Subject: TRIMMED: DA2024/1495 - Issues of concerns re DA2024/1495 82 Pacific

DA: DEVELOPMENT APPLICATION FOR THE DEMOLITION OF EXISTING DOUBLE GARAGE WITH LIKE FOR LIKE REPLACEMENT DOUBLE GARAGE WITH A FLAT

80-82 PACIFIC RDE, DEE WHY NSW 2099 SP 7795

REPLACEMENT OF OLD DOUBLE GARAGE WITH NEW GARAGE AND SLAB

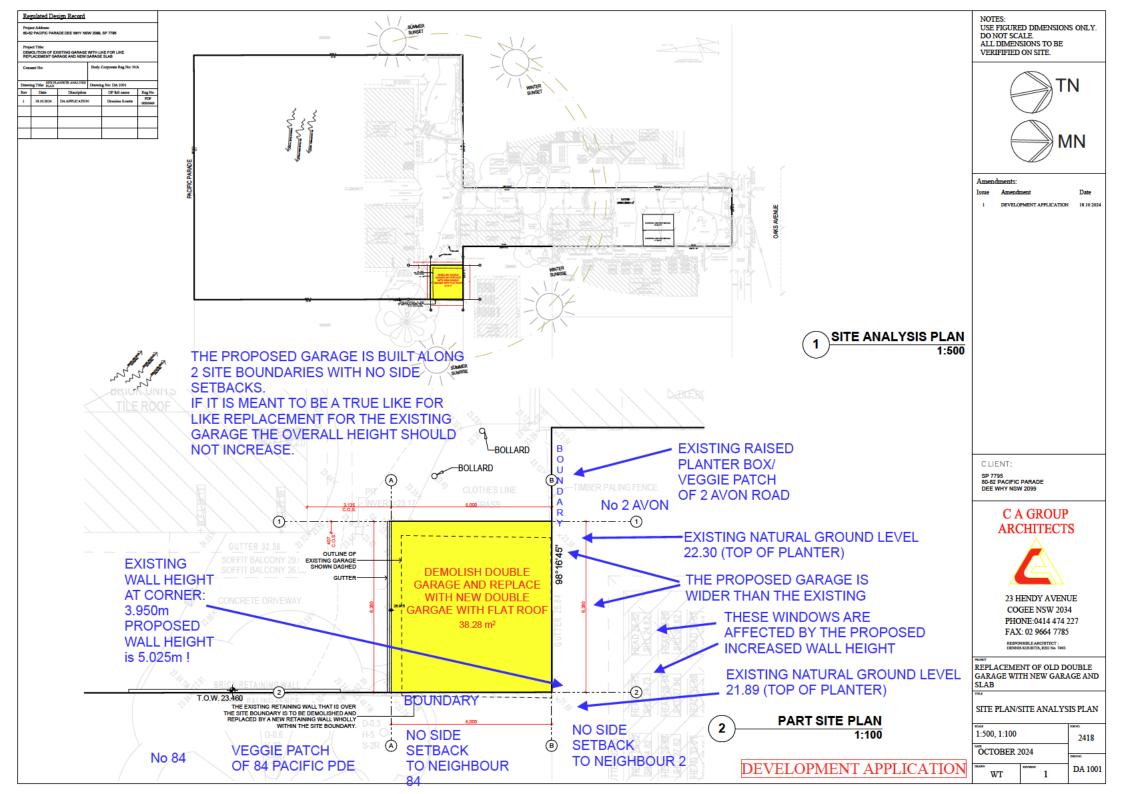
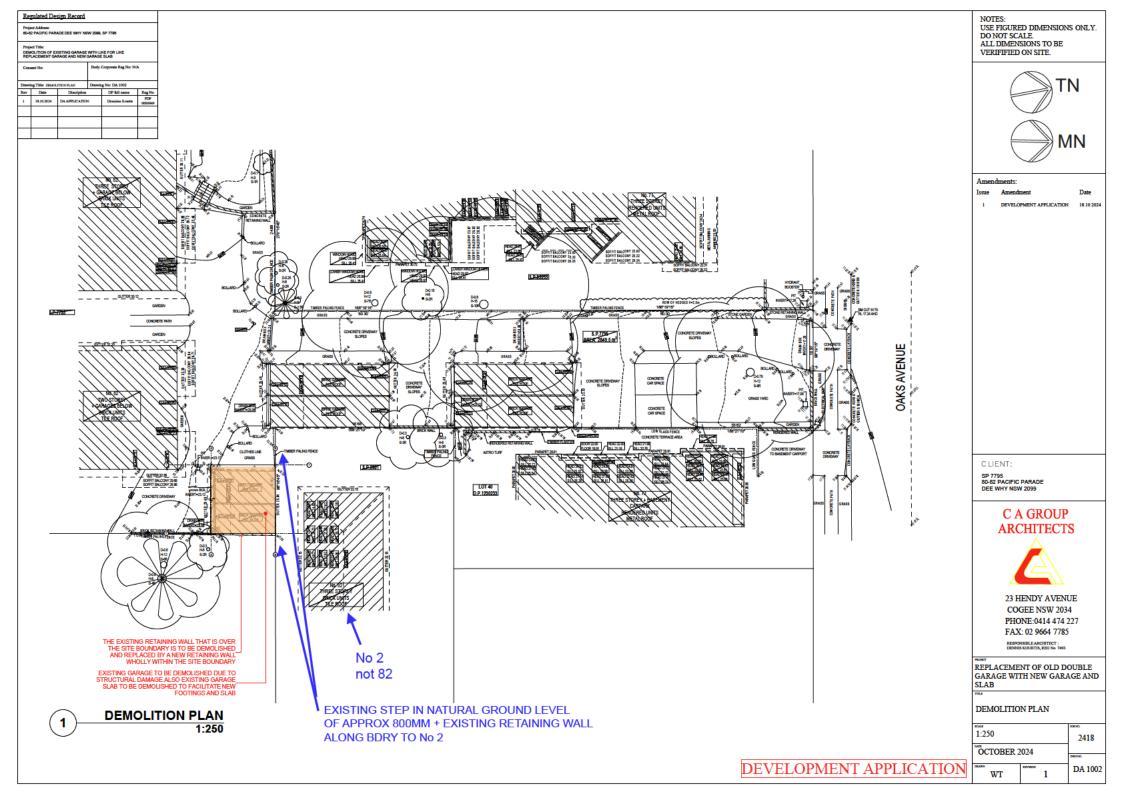
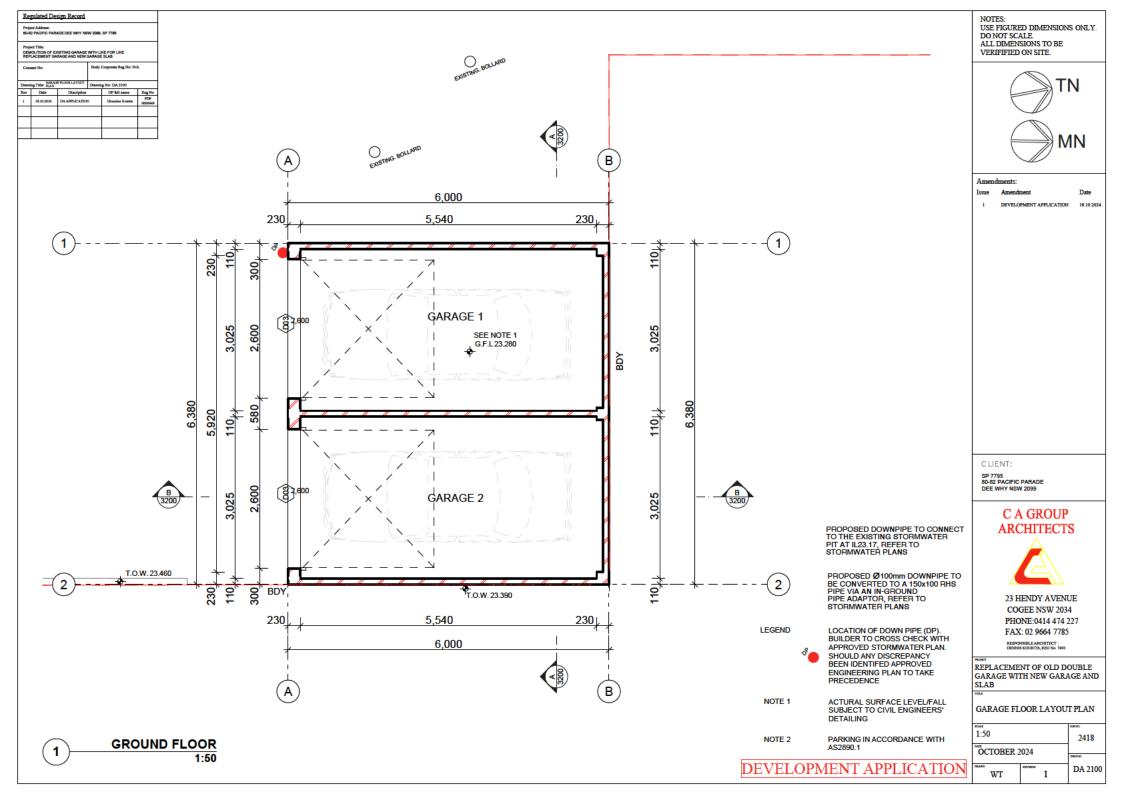
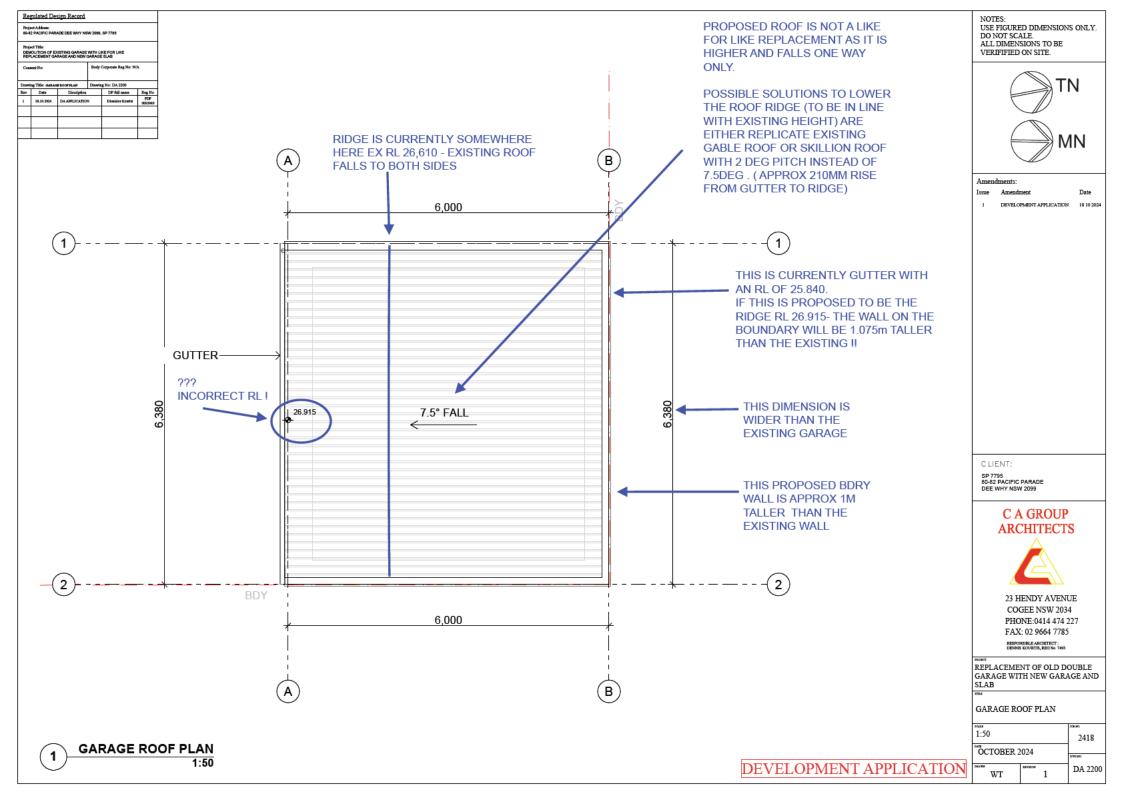
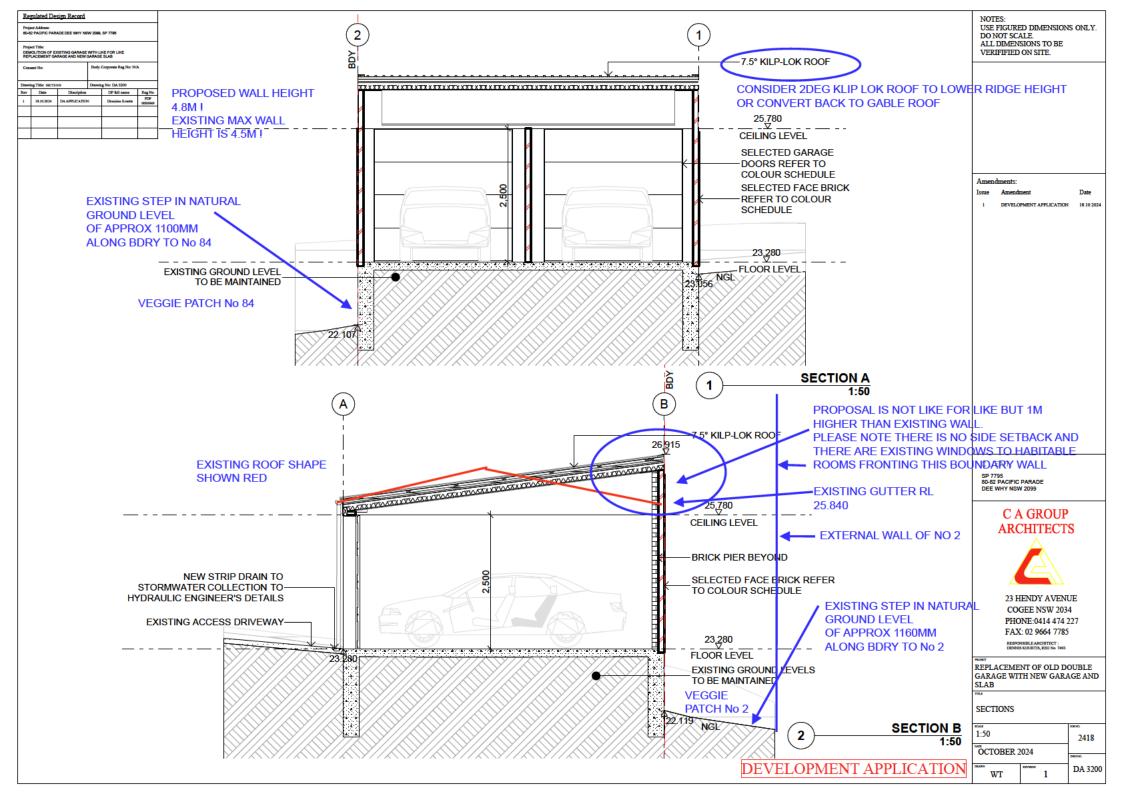
THIS IS NOT A LIKE FOR LIKE REPLACEMENT:

THE EXISTING GARAGE FEATURES A GABLE ROOF WITH A CENTRAL RIDGE. THE PROPOSED SKILLION ROOF HAS A 300mm HIGHER RIDGE AND ITS NEW LOCATION AT THE BOUNDARY WALL TO 2 AVON ROAD WILL INCREASE THE HEIGHT OF THE EXISTING BOUNDARY WALL BY

APPROX 1M.

THE PROPOSED ROOF IS NOT A FLAT ROOF BUT A 7.5DEG PITCHED SKILLION ROOF.

AFFECTED WINDOWS EXISTING RIDGE + ROOF SHAPE

SHOWN IN RED

COMMENTS FROM NEIGHBOUR 2 AVON ROAD IN BLUE

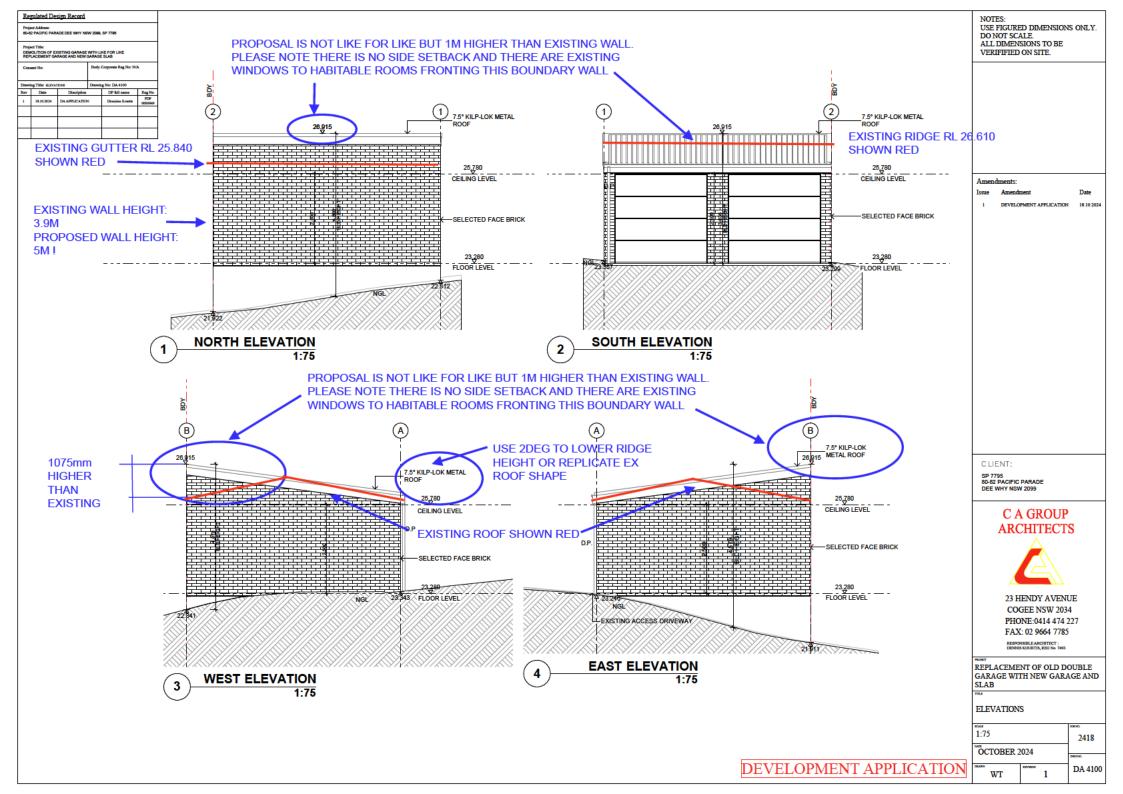
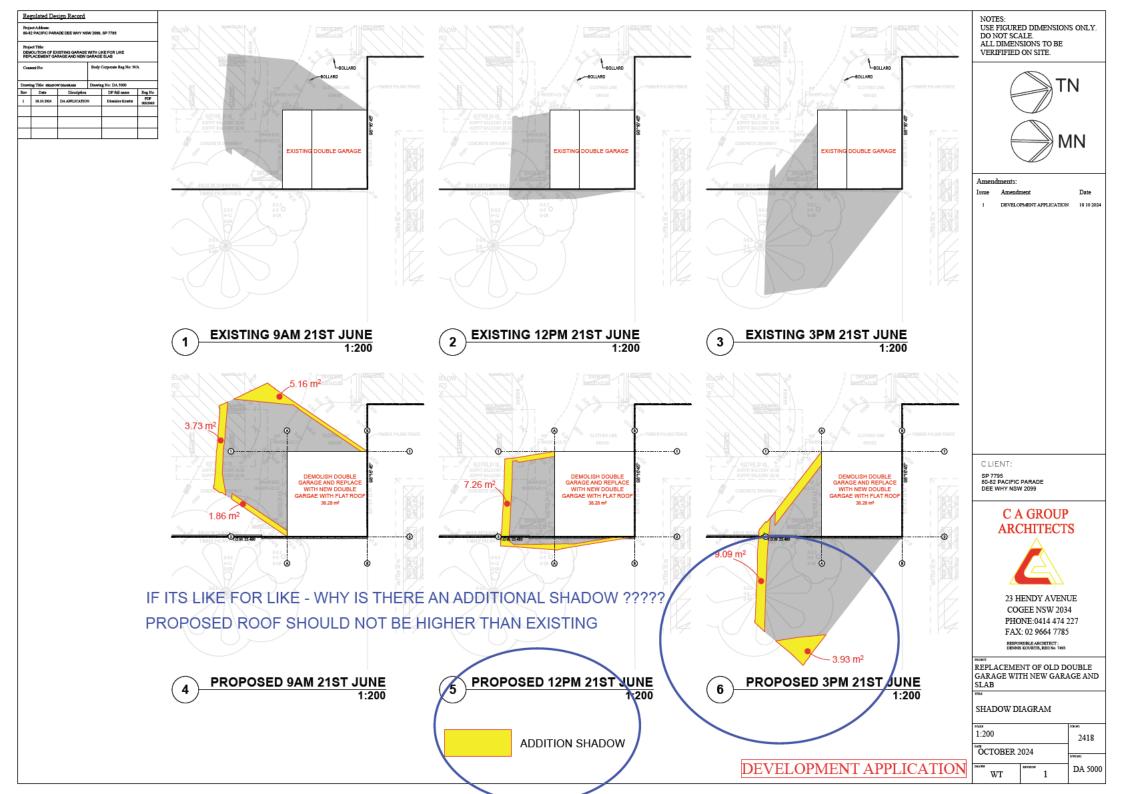
The current garage features a gable roof with an east west running ridge in the centre of the roof whereas the proposal- in spite of mentioning a flat roof - shows a skillion roof with a pitch of 7.5degrees and the ridge right at the northern boundary instead of at the centre of the roof. Changing the roof to a skillion roof with only one fall is not a like for like replacement and will have a negative impact (=increase) on the overall height of the build.

As mentioned before, the proposal -although advertised as like for like replacement with a flat roof documents a skillion roof with a roof pitch of 7.5deg. The new roof ridge is located right at the boundary with an RL of 26.915. This RL is not only higher than the existing ridge by approx. 300mm but due to its relocation to the edge of the roof the boundary wall will now be over a metre higher than it is currently- resulting in an overall height of over 5m. (taken from an already raised garden bed- please note the adjacent walkway is another 500mm lower.)

The proposed width of the garage exceeds the current footprint by approx. 350mm.

Option A: revert back to gable roof with central ridge to lower the overall ridge height and maintain existing heights and provide a true like for like replacement.

Option B: change pitch of skillion roof from 7.5 deg to the min recommended fall (the selected kliplok roof profile can be installed at 1deg min roof pitch but 2deg is industry standard/recommended). The height change from gutter to ridge would then only be approx. 200mm. Unfortunately this option would only work if the proposed ceiling height of the garage is lowered to allow for the ridge to still be below the existing gutter level of 25.840. The wall height towards 2 Avon Rd would need to be in line with the existing RLs.
